drawing title:
LEGENDS, SCHEDULES, EQUIPMENT LISTS, & NOTES

LMC SCIENCE 313-023-112.01-0-00.00
drawing no:
P0.1
drawing of ?

SCIENCE BUILDING
LOS MEDANOS COLLEGE
Pittsburg, CA
Contra Costa Community College District

RFI RESPONSES
DSA FILE # 7-C1
DSA APPL # 01-106226
DATE: 11/13/06
DSA NO. 01-106226
THIS REVISES IN PART
SHEET: P1.0
SHEET: SKM-408.1

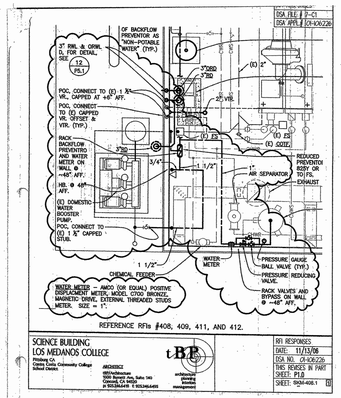
Per attached Dowdle RFI 67, there is no (E) 3" storm drain installed through the slab as shown. Please advise.

RFI RESPONSES
DATE: 11/13/06
DSA NO. 01-106226
THIS REVISES IN PART
SHEET: P1.0
SHEET: SKM-409.1

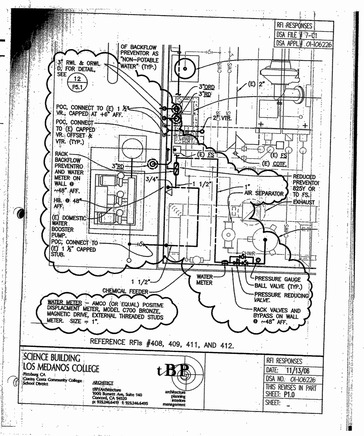
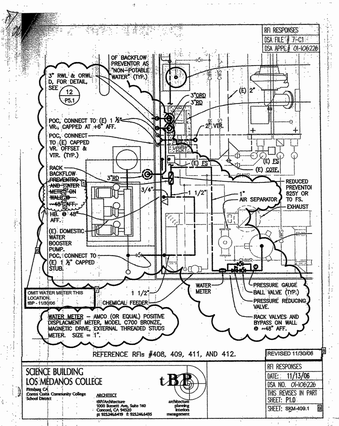
Per attached Dowdle RFI 68, there is no (E) 1 ½" water service installed through the slab as shown. Please advise.

Author: Weaver
Subject: Text Box
Date: 11/13/2006 8:19:08 PM
Drawing was issued during site prep phase and was not reflected in these drawings.
Contractor to provide and install 1 1/2" DW dbb (gate valve) at adjacent booster pump piping.
See attached sketch SKM-409.1 for details.

Comments: ☐ Mark:
Attached find revised sketch SKM-409.1 to reflect deletion of the water meter located at the west wall. South meter remains and as described.
Please replace this sheet for the one dated 11/13/06 of RFI 409.
Let me know if any question.
Thanks.
Jim.

RFI RESPONSES
DATE: 11/13/06
DSA NO. 01-106226
THIS REVISES IN PART
SHEET: P1.0
SHEET: SKM-412.1

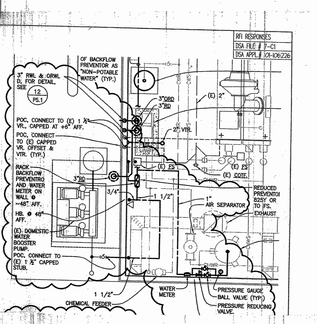
Per attached Dowdle RFI 71, there is no make-up water indicated for the chilled water loop. Please advise.

Note: Per owner, provide with flow meter, pressure reducing valve, pressure gauge, and bypass line.

PLUMBING - MECHANICAL/CHILLER/PUMP BUILDING

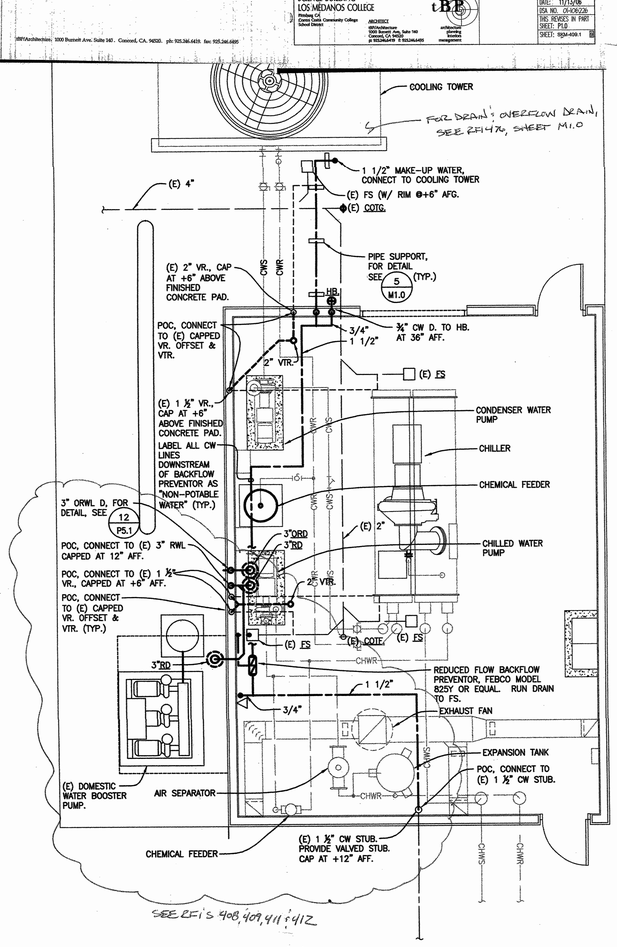
Per attached Dowdle RFI 69, there is no overflow drain to be installed at the Chiller building canopy. Please advise.

Request: Date Required: 11/2/2006
Canopy @ Pump Building does not show an Over Flow Drain. Is this required?

Per attached Dowdle RFI 70, there is a ¾" CW drop prior to POC at the BFP. Is this to be capped for future use? Please advise.

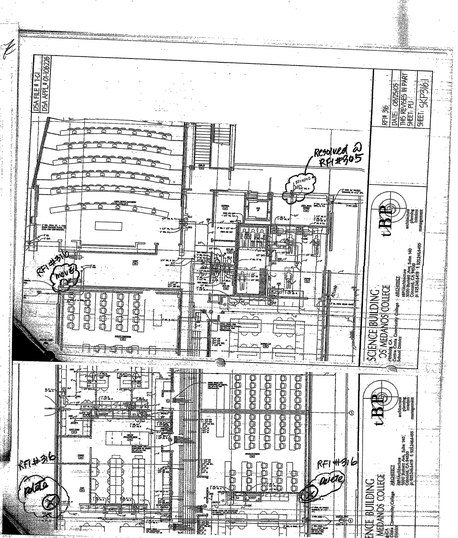
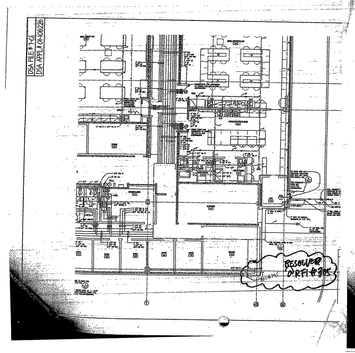
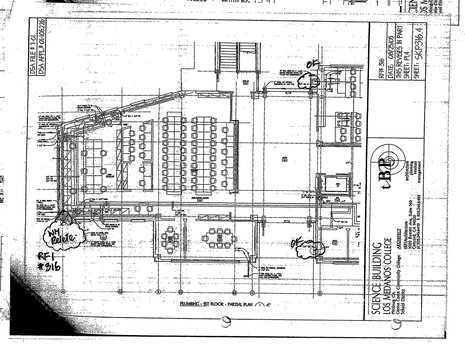
INFORMATION REQUESTED:
The response to RFI 205 suggests that water hydrants mounted in exterior walls are not desirable in metal panel locations. However, there are still 4 water hydrants that are located in metal panel locations. These locations are as follows:
E-line at G-line
E-line at 5.8-line
H-line at 5.8-line
5-line near G-line

The last of these locations can easily be installed just around the corner east of G-line. The other 3 locations are not near plaster. Please advise if these are to be relocated or eliminated. If they are to be installed where shown, *please provide a detail for waterproofing.*

Relocated / remove wall hydrants as indicated on attached sketches SK316.1 to SK316.4. Provide credit for the removal of the 3 wall hydrants and associated piping/hangers/supports, etc.

Note that all exterior wall mounted water hydrants are to be mounted in cement plaster walls. All water hydrant are to be located at least 1'-0" to exterior metal panel wall finish. Also see the response to RFI #305.

PLUMBING - 1ST FLOOR - PARTIAL PLAN

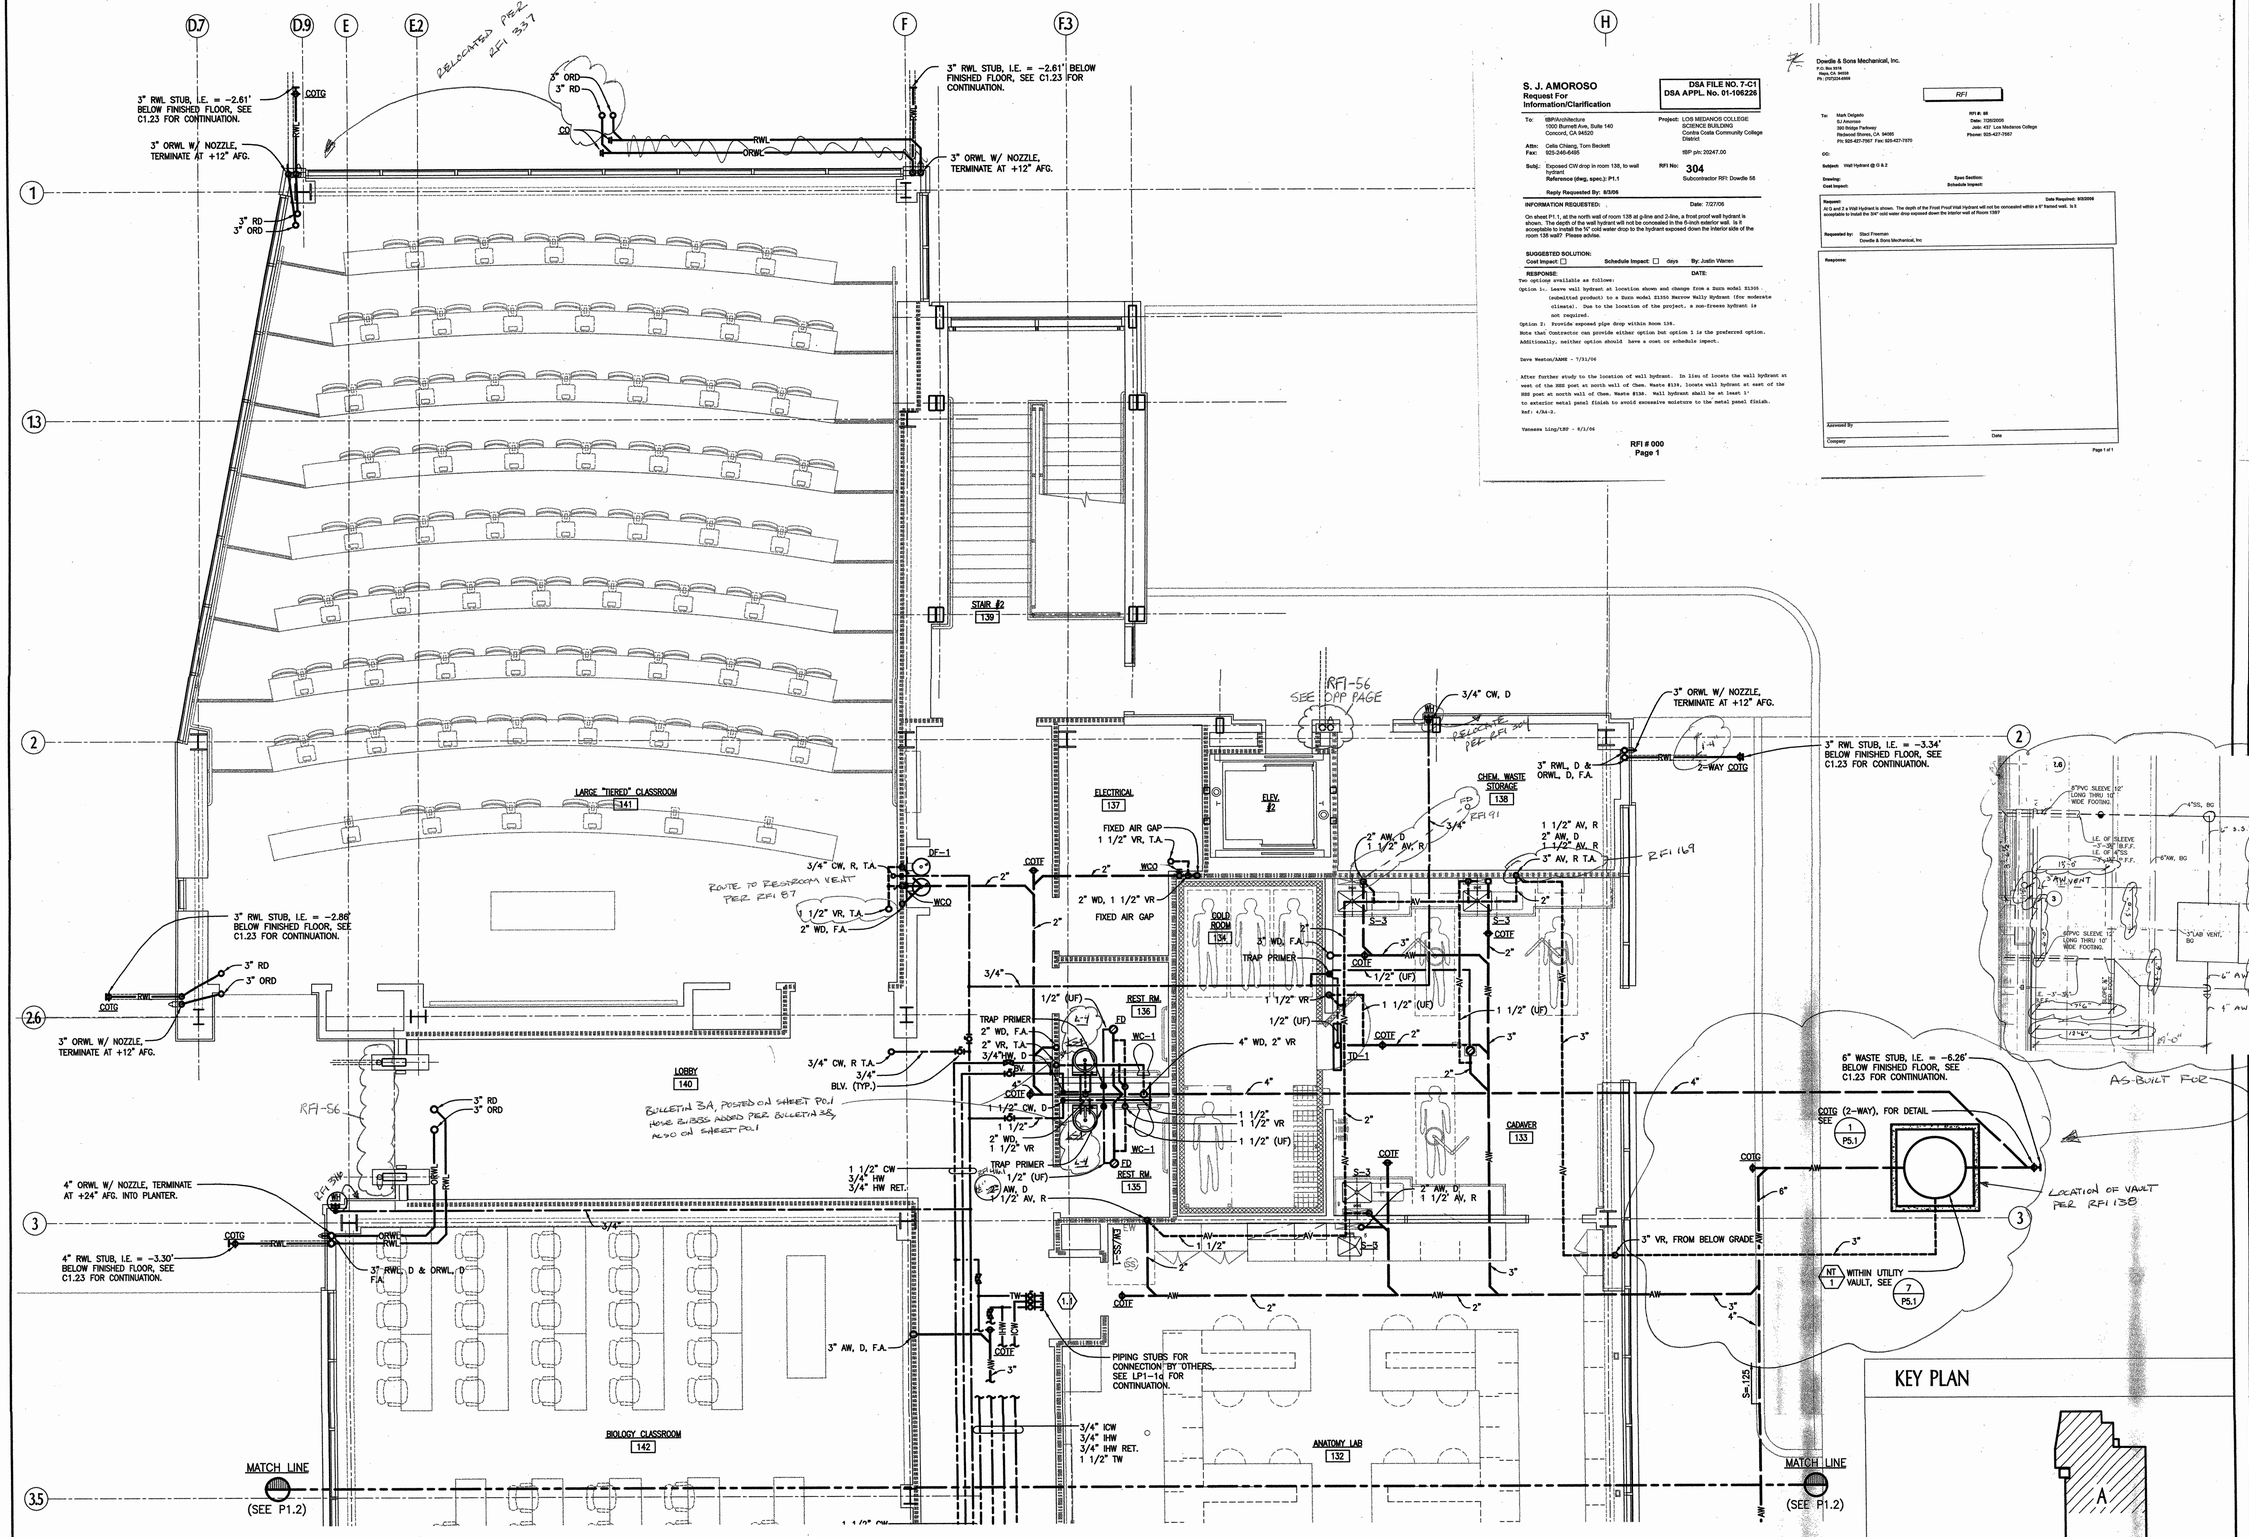
INFORMATION REQUESTED:
Please note the attached Dowdle and Sons RFI No. 34 regarding the Acid Waste Utility Vault - shown on P1.1 at 2.0 and H.9 line. Please provide dimensions to vault from gridlines.

INFORMATION REQUESTED:
Please note the attached Dowdle and Sons RFI No. 37 regarding an AV shown to continues up to the second floor which is blocked by a 1838x852. Please provide an alternate route or wall furring detail allowing access.

On sheet P1.1, at the north wall of room 138 at g-line and 2-line, a frost proof wall hydrant is shown. The depth of the wall hydrant will not be concealed in the 6-inch exterior wall. Is it acceptable to install the 16" cold water drop to the hydrant exposed down the interior side of the room 138 wall? Please advise.

Felipe, your plumbing subcontractor and I walked the area where the acid waste utility vault is to be placed.
We agreed that the POC installed at site preparation needs to be exposed to determine its exact location and to verify size…4" or 6". Once that information is known, we agreed the plumber would determine the best route and means to accomplish the connection of each of the 4" building sanitary lateral and the outfall pipe from the acid waste tank.
We discussed the fact that the acid waste utility vault must land entirely within the adjacent roadway due to the need for frequent inspection and maintenance to replenish the limestone within. The top elevation of the tank will be + 1" to the asphalt roadway, whose elevation will be determined by interpolation of the drain inlet elevations which are adjacent to either side of the utility vault.
Felipe was cautioned that the SK2 drawings we provided previously may require the adjustment of the current finish elevation of either or both of the drain inlets, which should be considered as a part of determining the acid waste vault top elevation.

Author: Deskbot
Subject: None
Date: 3/2/2006 7:55:28 PM
Comment: Contractor's field verification does not believe double void within common (double) wall between Elevator Machine Room 259 and Storage Room 261. Locate vent within Storage Room portion of the double wall.

RESPONSE: DATE:
Two options available as follow:
Option 1: Leave wall hydrant at location shown and change from a Zurn model Z1355 - (submitted product) to a Zurn model Z1350 Narrow Wally Hydrant (for moderate climate). Due to the location of the project, a non-freeze hydrant is not required.
Option 2: Provide exposed pipe drop within Room 138.
Note that Contractor can provide either option but option 1 is the preferred option. Additionally, neither option should have a cost or schedule impact.

1/P1.4

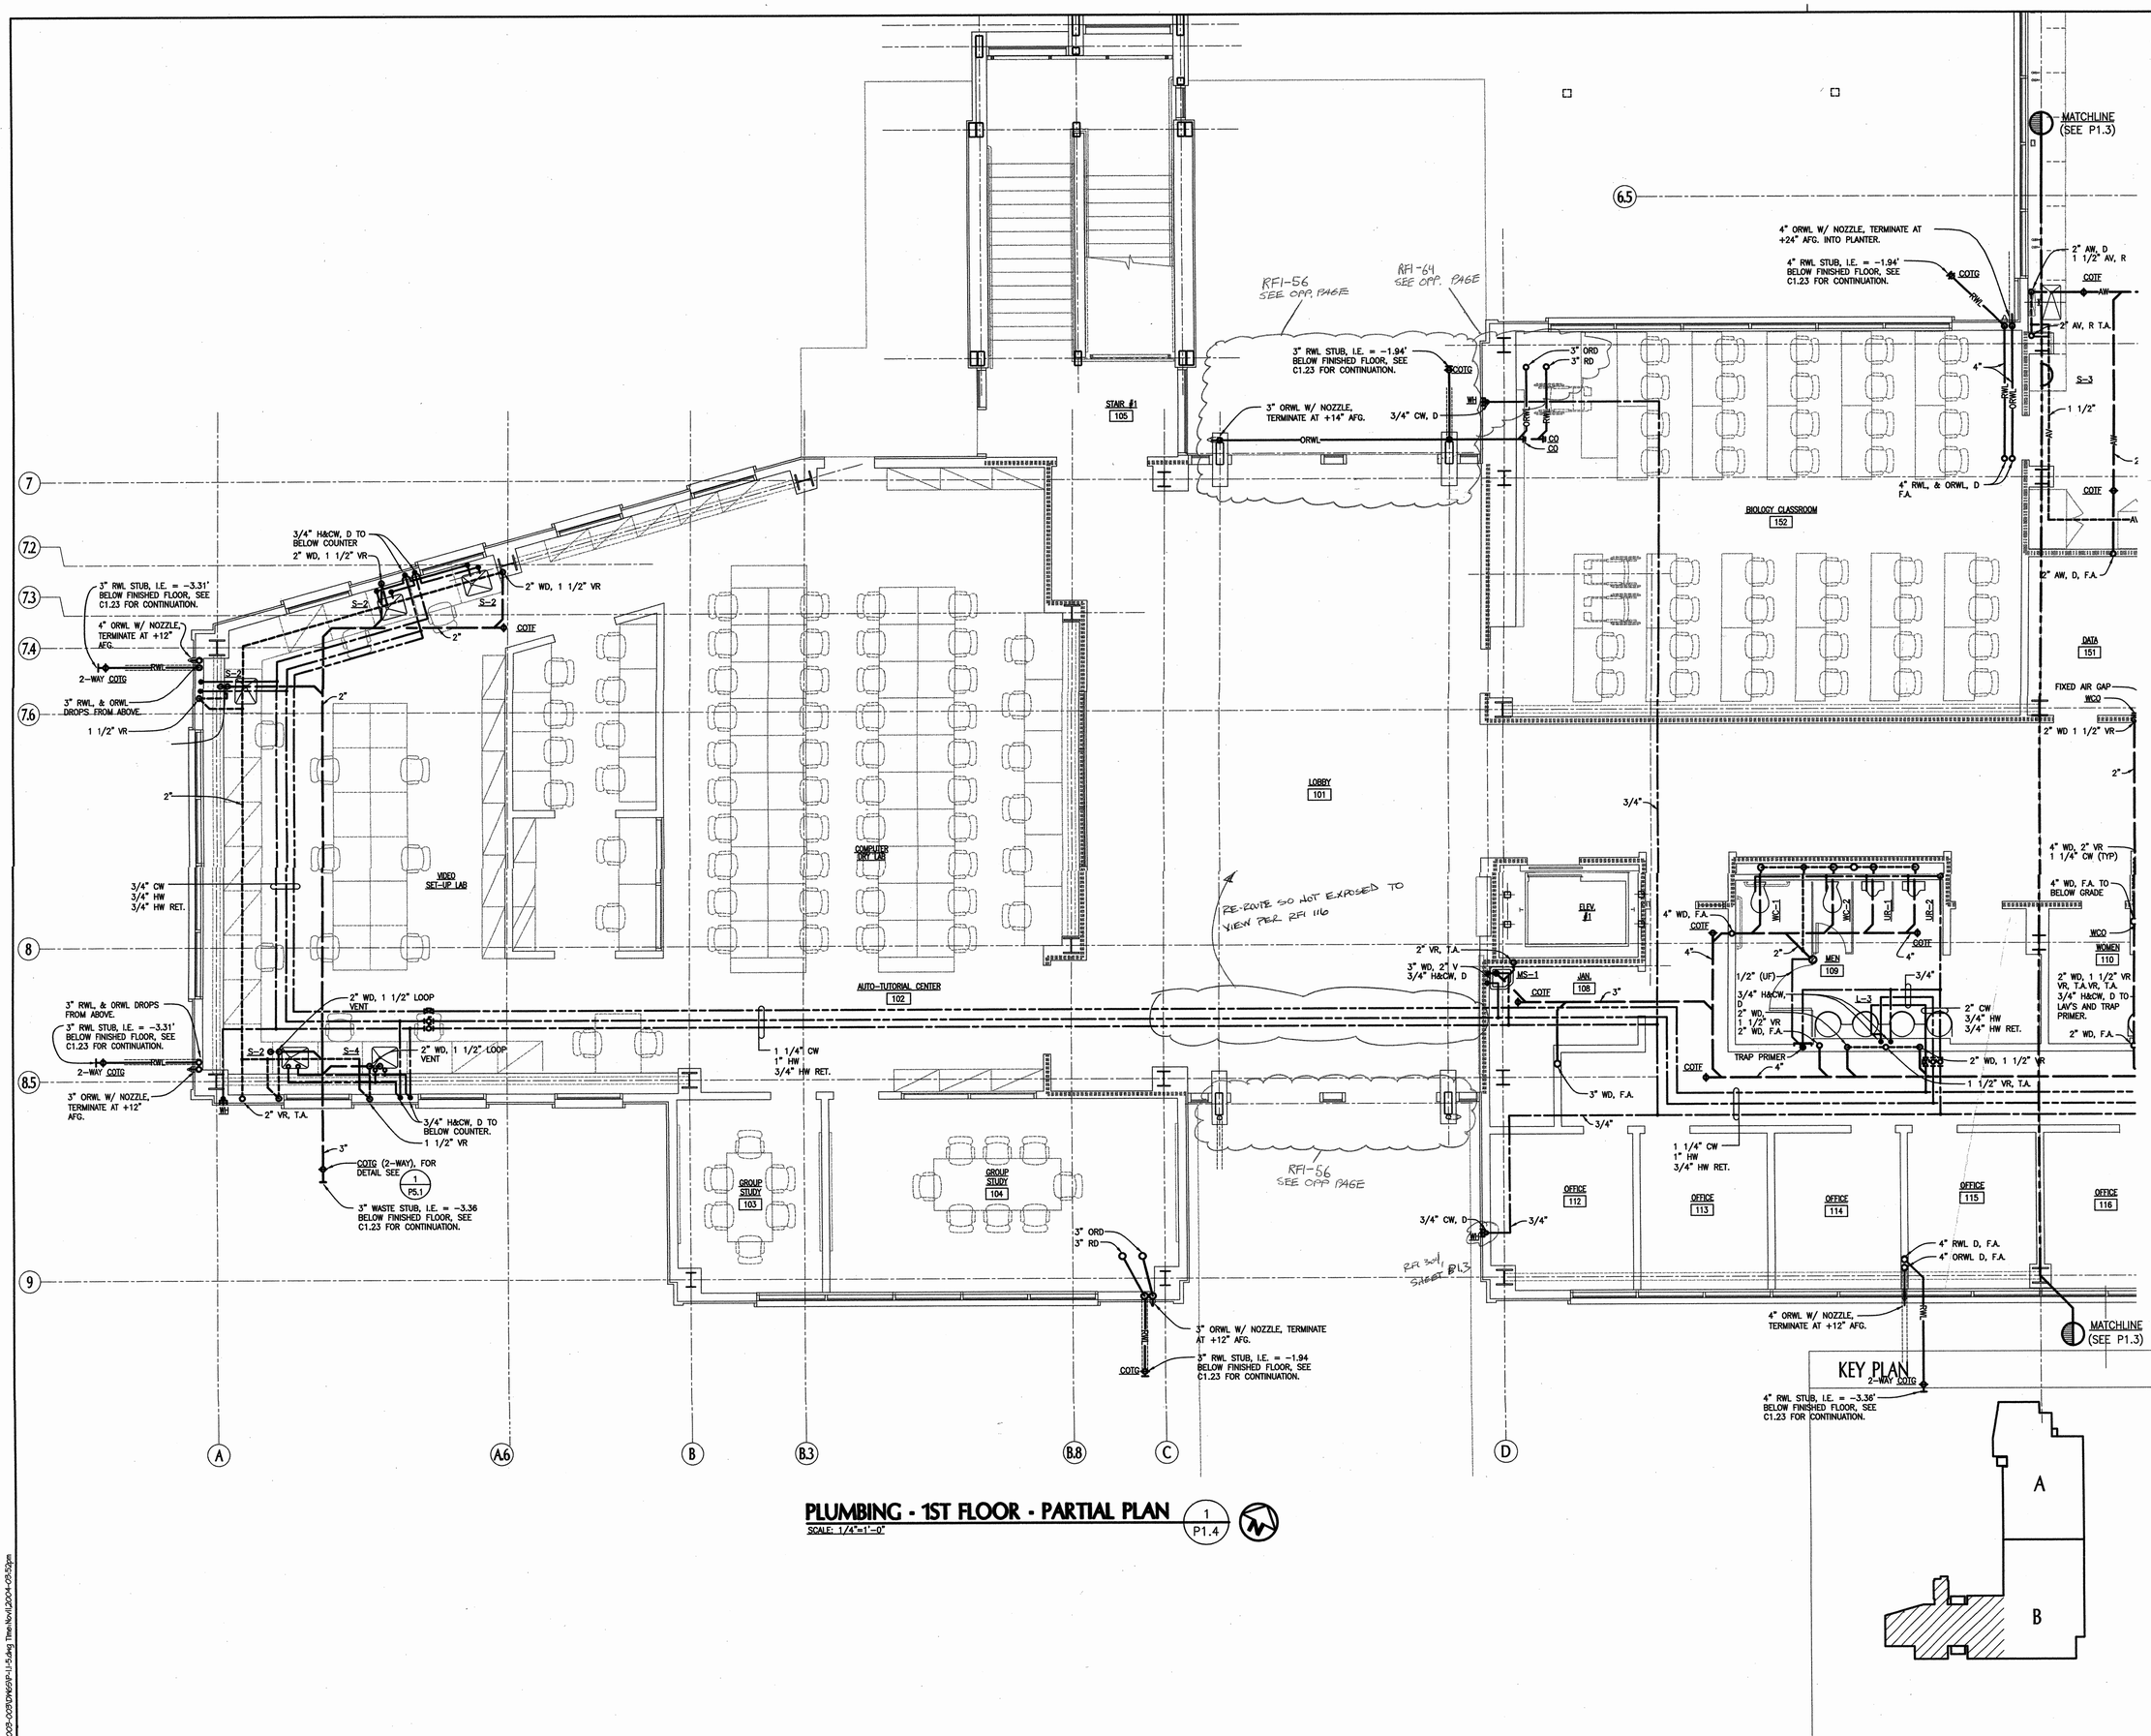
Request: Date Required: 2/7/2006
P1.4 shows domestic water mains exposed between 8 and 8.5 @ CID Lines. Support for this piping would be from Roof Deck along with required seismic bracing. Please clarify.
